ADDENDUM #7

TO THE CONTRACT DOCUMENTS FOR THE CITY OF PALM BAY

IFB # 39-0-2020/JG, South Regional Water Reclamation Facility Construction

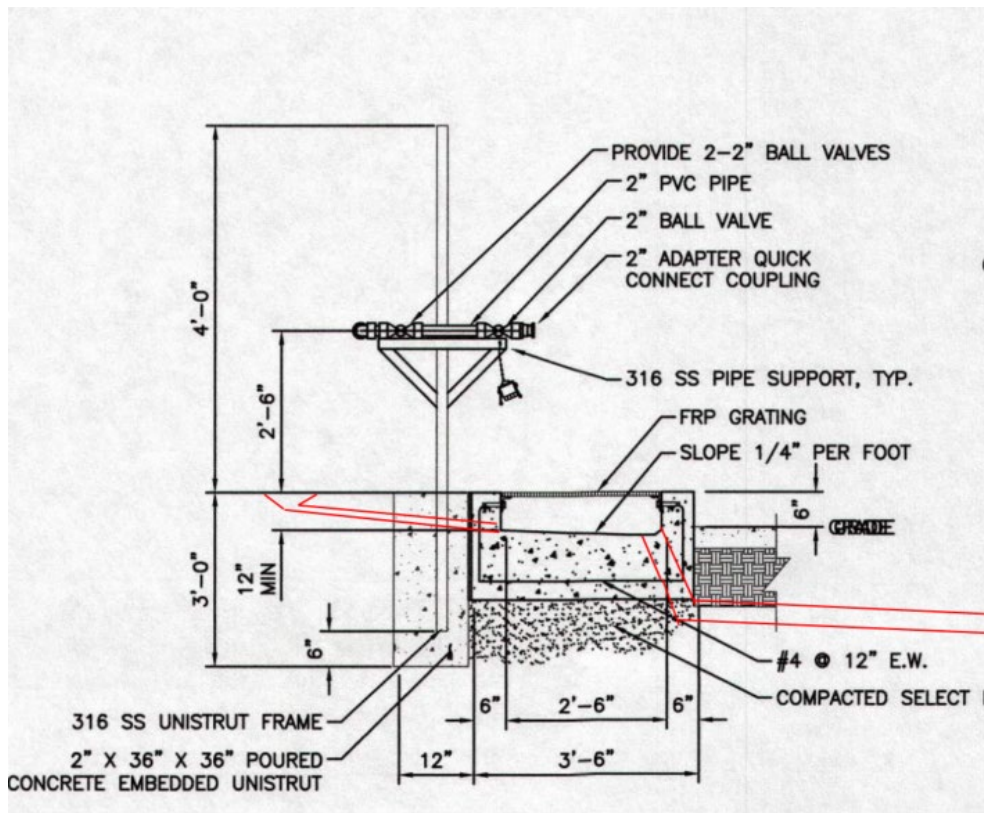
- A11. Refer to Article 30 (Substitute Material and Equipment) of the Invitation for Bid document (starts on page 21).
- Q12.** Drawings C-16 and C-22 each show 1" RCW piping going to both the High Service Pump Station and Chemical Storage. Drawings P-20 and P-26 do not show any RCW piping required at either of these locations. Please clarify the requirements for RCW piping at each location.

- A12. Remove the 1" RCW shown on C-16 and C-22 highlighted below.

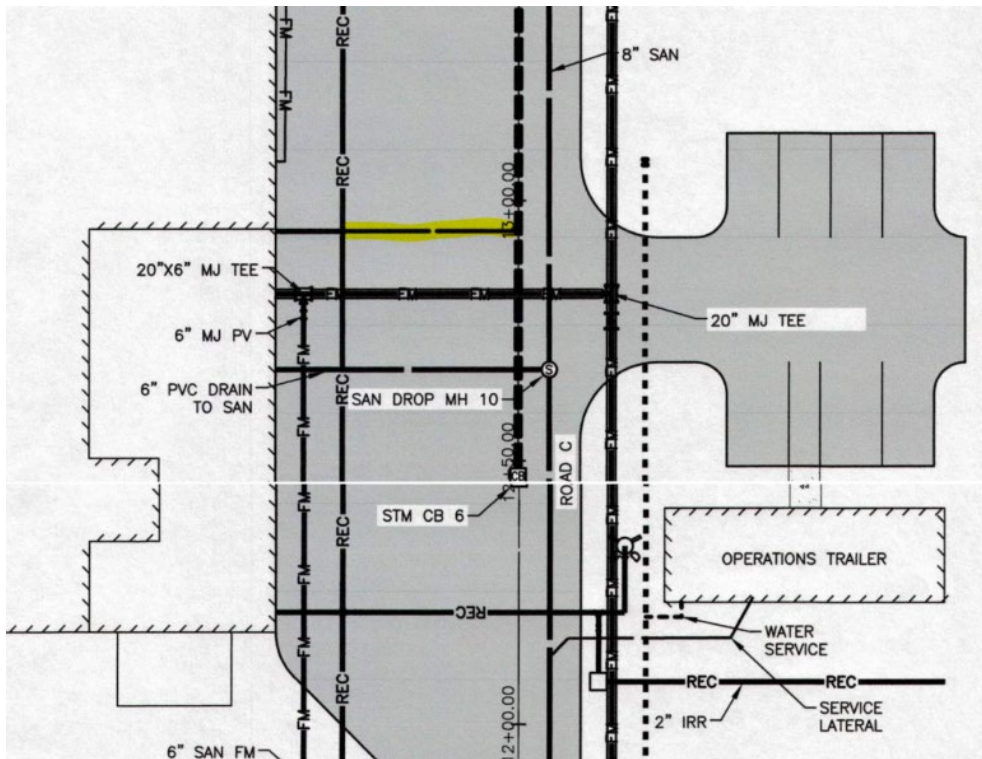
Q17. Drawings C-16 and C-21 show a line between the 4" REC piping and the 18" STM piping at approximately station 13+00 in Road C. These drawings indicate that a 4" REC line goes west from the 4" tee to the north end of the Headworks, but there is no indication of what the line between the REC and STM piping is. Please clarify the requirements for piping at this location.

A17. On C-16 and C-21 delete the highlight section of pipe below:

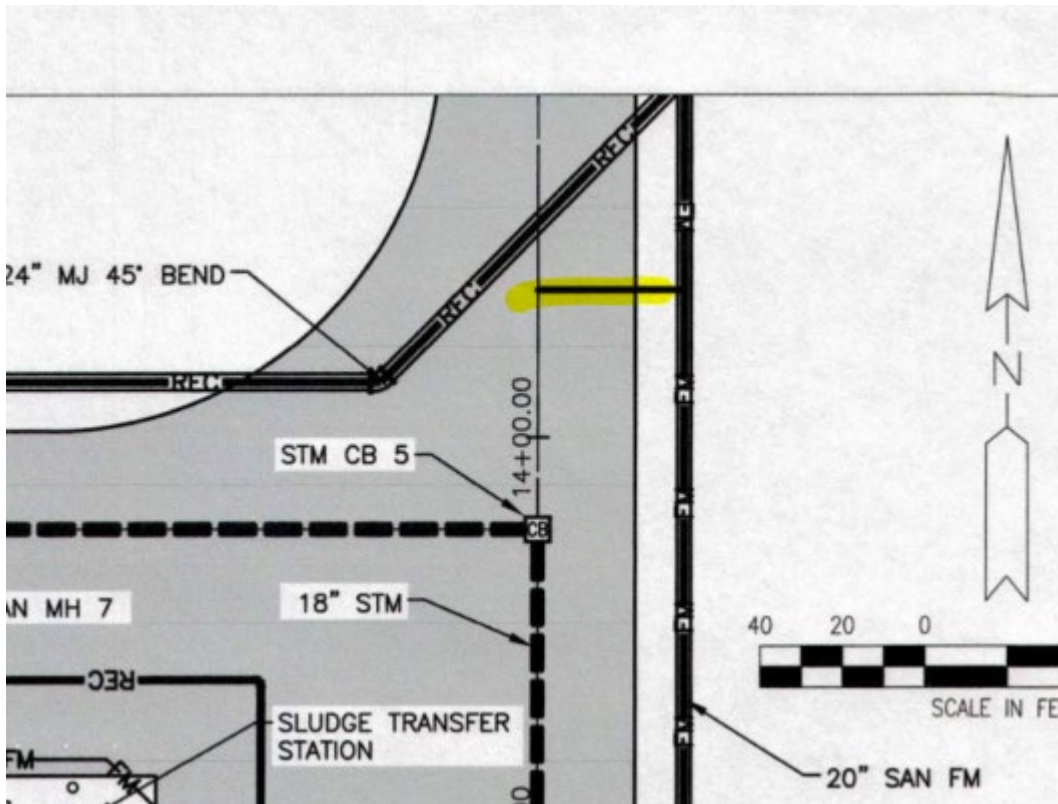
Q18. Drawings C-16 and C-21 show a line between the 20" SAN FM and the centerline of Road C at approximately station 14+20. The profile on Drawing C-21 shows the southern 20" 11.25° bend near this location, but there is no indication of any piping heading to the west of the SAN FM at this location. Please clarify the requirements for piping at this location.

A18. On C-16 and C-21 delete the highlight section of pipe below:

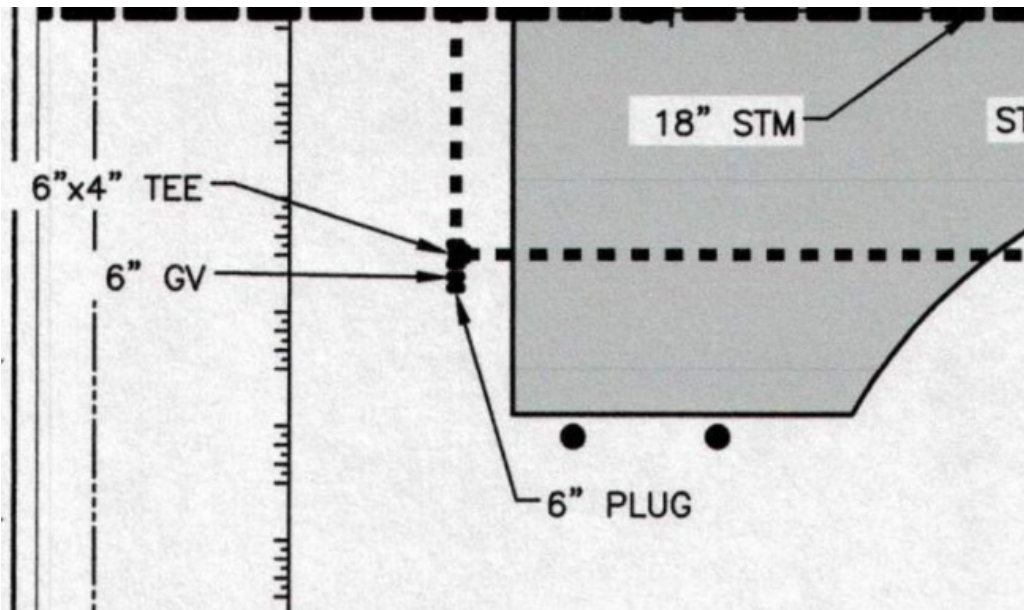
Q20. The note attached to the 12" influent pipe at the wetwell in the Plant Drain Lift Station Plan on Drawing P-21 says "MIN. 32 LF. DR 18 PVC". On Drawings C-16, C-20, and C-22 this 12" line scales approximately 27 LF. Specification 02730, Paragraph 2.01 B.2. requires SDR 35 piping for the Sanitary Sewer system. Please clarify the following:

A. Is 32 LF. of piping required between SAN MH 1 and the wetwell, placing the wetwell approximately 5 feet farther east than shown on Drawings C-16, C-20, and C-22?

Should the pipe between SAN MH 1 and the wetwell be SDR 35 as specified? If DR 18 piping is required at this location, please provide a specification for the piping.

A20. Revise "MIN 32 LF. DR 18" to "MIN 5 LF." Use SDR 35 pipe as specified.

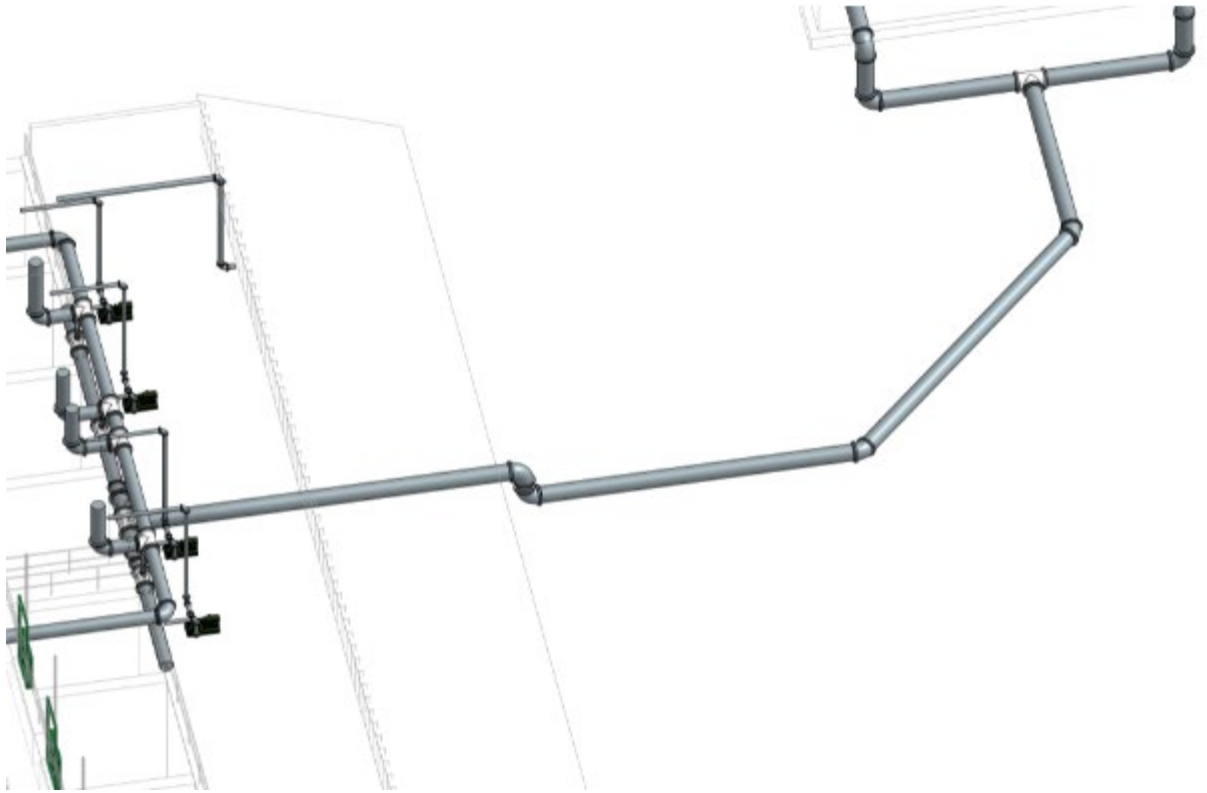
Q47. Section 11100 / 2.04.A.2 states that the size of the surge tank is to be determined and fixed by the supplier's surge analysis or one provided by the owner. Has the owner conducted an analysis yet?

A47. Surge analysis will not be required.
Section 11100 will be removed and the requirements for the surge tank will be shown on the revised drawing of P-19 as per the attached markup.

1. CENTERLINE ELEVATION OF 4" PLANT REUSE WATER SUCTION PIPE IS THE SAME ELEVATION AS THE SUCTION OPENING OF THE PUMP AFTER SECURING PUMP AND BASE TO CONCRETE HOUSEKEEPING PAD. THE CONTRACTOR SHALL CORE THROUGH THE CHLORINE CONTACT TANK WALL ONLY AFTER THIS CENTERLINE HAS BEEN DETERMINED. SUCTION PIPING SHALL REMAIN LEVEL BETWEEN THE WALL AND THE PUMP.
2. ALL PLANT REUSE WATER LINES SHALL BE PAINTED PURPLE.

3. THE MANUFACTURER SHALL PROVIDE ALL MATERIALS, EQUIPMENT AND INCIDENTALS REQUIRED TO FURNISH, TRANSPORT AND PLACE INTO OPERATION THE HYDROPNEUMATIC BLADDER TANK.

a. SHOP DRAWING SUBMITTALS SHALL BE IN ACCORDANCE WITH SECTION 01300 AND SHALL INCLUDE DRAWINGS SHOWING DETAILS OF CONSTRUCTION, EQUIPMENT DATASHEETS AND SOURCE QUALITY CONTROL TEST REPORTS. OPERATION & MAINTENANCE DATA SHALL BE SUBMITTED AS PER SPECIFICATION SECTION 01730.

b. TANK SUPPLIER SHALL PROVIDE A MINIMUM OF FIVE REFERENCES OF COMPARABLE INSTALLATIONS. ALL WELDERS WORKING ON THE FABRICATION OF THIS TANK SHALL BE ASME CERTIFIED. TANK SHALL BE AN FXA-STYLE TANK, DESIGNED IN ACCORDANCE WITH ASME SECTION VIII.

c. TANK SHALL BE FURNISHED WITH A REPLACEABLE HEAVY-DUTY BUTYL BLADDER, NPT EPOXY LINED CONNECTIONS AND A CHARGING VALVE TO ADJUST AIR PRESSURE. SYSTEM SHALL BE FURNISHED WITH A PRESSURE GAUGE AND A BLADDER INTEGRITY MONITOR.

d. TANK CONSTRUCTION SHALL BE AS FOLLOWS:

- MATERIAL: CARBON STEEL
- ORIENTATION: VERTICAL
- EPOXY COATING IN ACCORDANCE WITH SECTION 09900 OF THE SPECIFICATIONS.
- MINIMUM VOLUME: 2600 GAL
- DIMENSIONS: 72" (D) x 172" (H)

e. ACCEPTABLE MANUFACTURERS ARE: WESSEL COMPANY (MODEL FXA-10000-HP) OR APPROVED EQUAL.
